OUZINKIE OFFICE
 OUZINKIE NATIVE CORP.
 SPRUCE ISLAND, ALASKA

ELECTRICAL SHEET LIST	
NUM	SHEET TITLE
E0.1	LEGEND
E0.2	SPECS.
E0.3	SCHEDULES
E1.1	CRAWLSPACE ELECTRICAL PLAN
E2.1	LEVEL 1 LIGHTING PLAN
E2.2	LEVEL 2 LIGHTING PLAN
E3.1	LEVEL 1 POWER AND SIGNAL PLAN
E3.2	LEVEL 2 POWER AND SIGNAL PLAN
E4.1	ONE-LINE DIAGRAMS, DETAILS, AND SCHEDULES
E5.1	PANEL SCHEDULES
E5.2	PANEL SCHEDULES
TOTAL SHEETS: 11

* 27 NOVEMBER 2017 * ADDENDUM NO. 1 *

1 CRAWLSPACE ELECTRICAL PLAN
E1.1 SCALE: 1/4" = 1'-0"

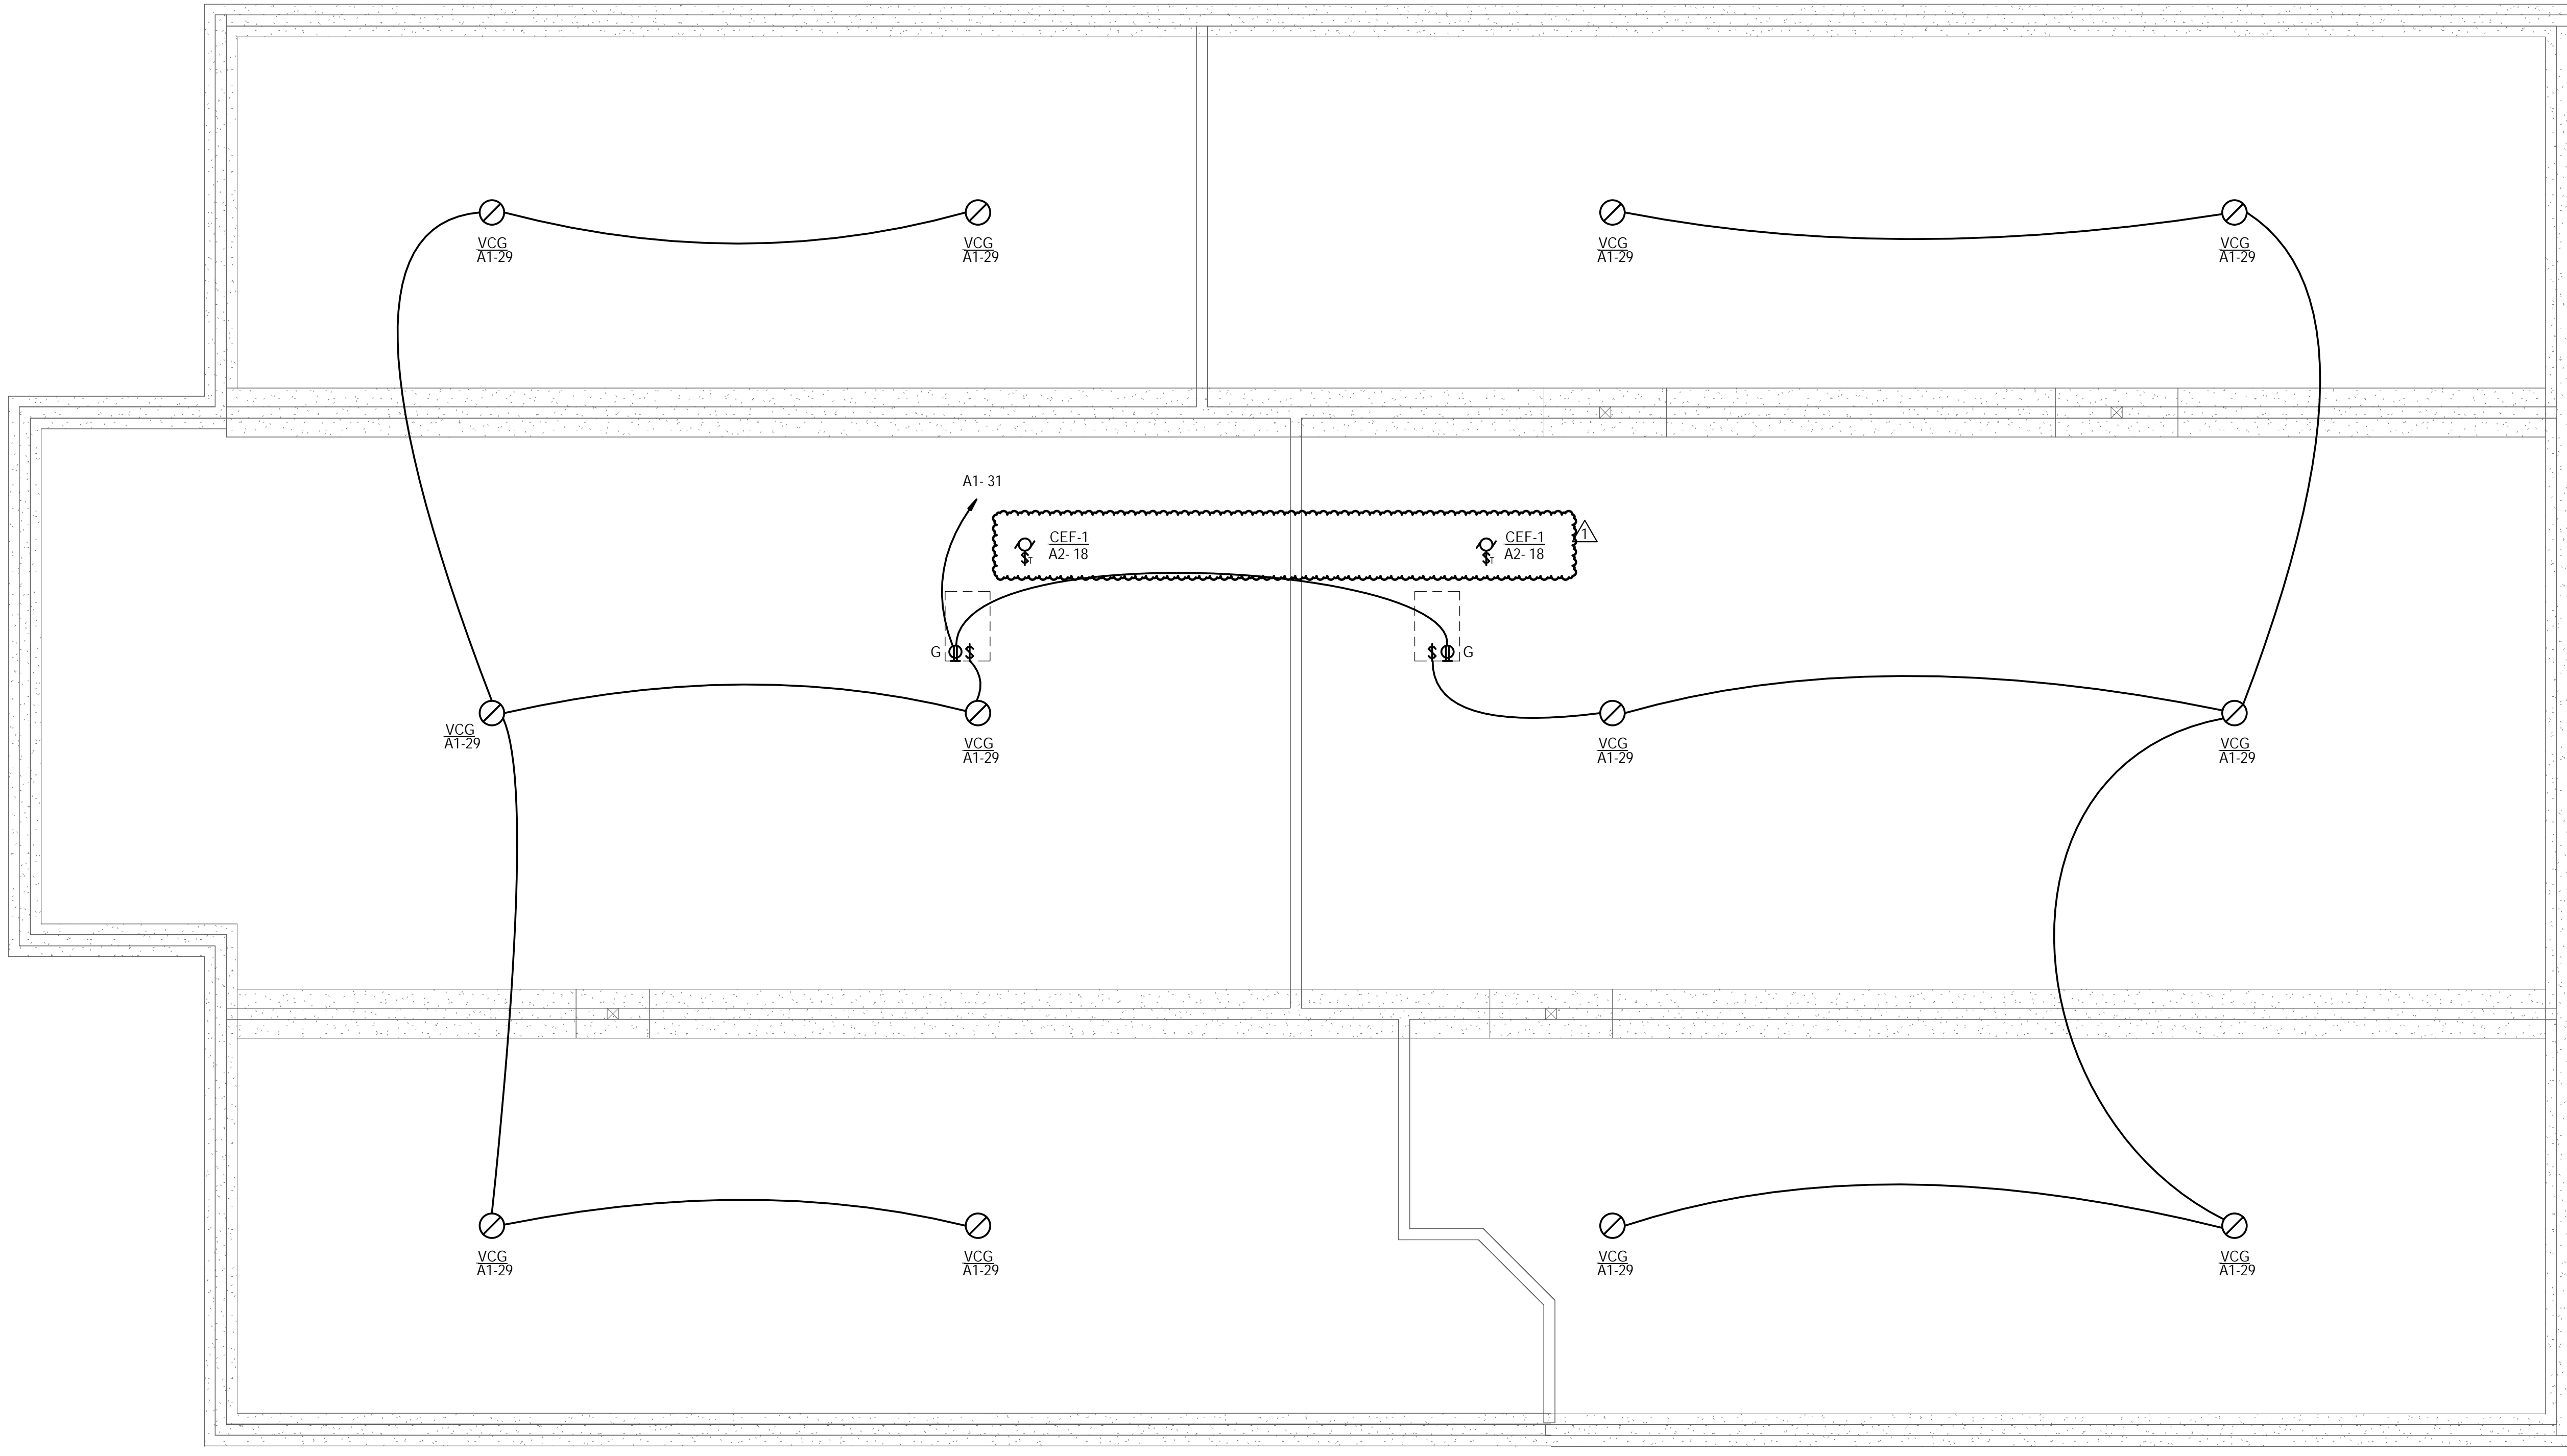
NUM	DATE	DESCRIPTION
1		REVISIONS REV 1 - CRAWLSPACE ONE-LINE ELECTRICAL TYPES - 11/27/2017
